Access Compliance Report

Public Rights-of-Way

(Curb Ramps)

Intersection ID: 24840	Main Street: REA_RD	Cross Street: MACANDREW_DR	Location: SE
ADA ID: 7E49551140C9	Ramp Type: Perp	Initial Pass/Fail: Fail	Overall Compliance: No
		Severity Score: 1.25

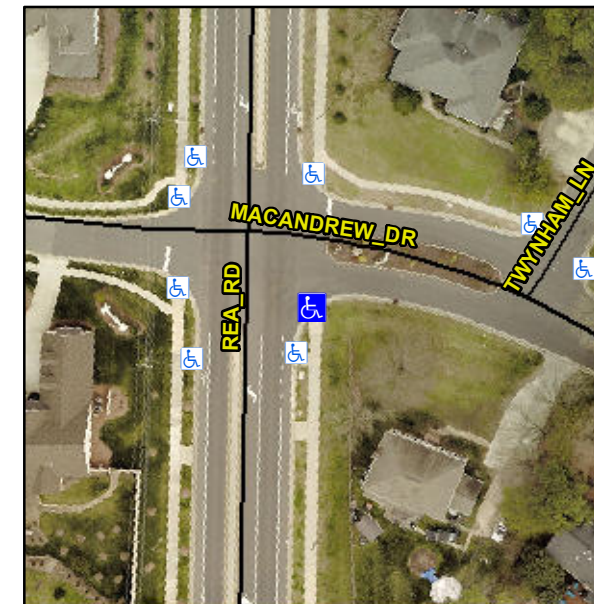
Not Found, R304.5.3

Compliance	Description	Data	Compliance	Description	Data
N/A	Ramp Length (in)	80.0	Yes	Ramp Slope (%)	5.2
Yes	Ramp Width (in)	88.0	No	Ramp XSlope (%)	2.6
N/A	Flare Type LT	N/A	N/A	Flare Type RT	N/A
N/A	Flare Slope LT (%)	N/A	N/A	Flare Slope RT (%)	N/A
N/A	Flare Traversable LT?	N/A	N/A	Flare Traversable RT?	N/A
N/A	Landing Length (in)	N/A	N/A	DWS Provided?	N/A
N/A	Landing Width (in)	N/A	N/A	DWS Contrast?	N/A
N/A	Landing Slope (%)	N/A	N/A	DWS Length (in)	N/A
N/A	Landing X Slope (%)	N/A	N/A	DWS Full Width?	N/A
N/A	Landing Curb? (Y/N)	N/A	N/A	DWS Offset (in)	N/A
N/A	Shared Landing?	N/A			
N/A	Gutter Ponding?	N/A	N/A	Gutter Slope (%)	N/A
N/A	Gutter Lip Ht (in)	N/A	N/A	Gutter X Slope (%)	N/A
N/A	Painted X Walk1?	No	N/A	Painted X Walk2?	N/A
	X Walk 1 Direction	To NW		X Walk 2 Direction	N/A
N/A	X Walk 1 Width (in)	N/A	N/A	X Walk 2 Width (in)	N/A
	X Walk 1 Slope (%)	0.9		X Walk 2 Slope (%)	N/A
	X Walk 1 X Slope (%)	2.5		X Walk 2 X Slope (%)	N/A

Remove & Replace Entire Ramp.
